2019 Vancouver Building By-law

April 10, 2019 – Upcoming Change Proposals

Change Proposals

Figure above.: Fire Test of Water curtain sprinklers

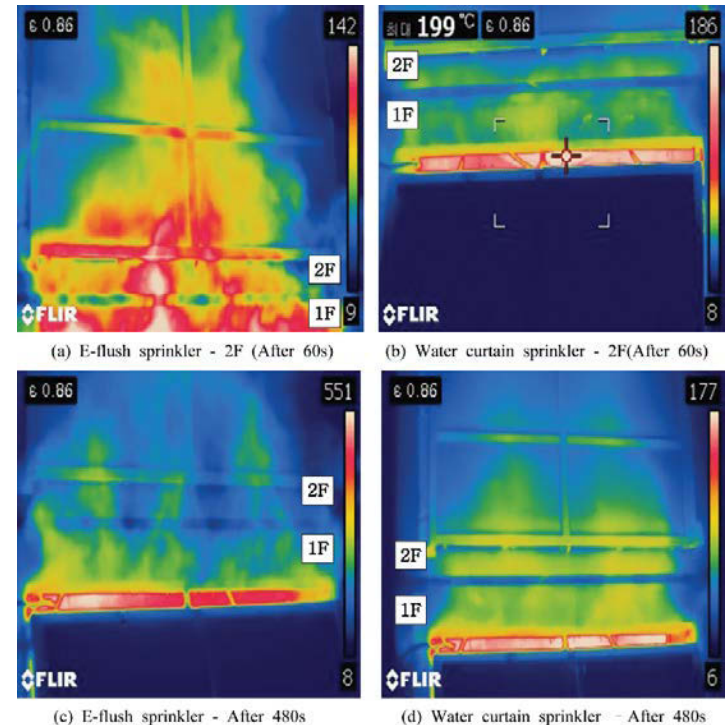
- Sprinkler water curtain for exit exposure option first provided in 2014 VBBL
 - Propose removal of 10 person limitation
 - More comprehensive requirements
- Can still propose alternative solutions for unusual cases
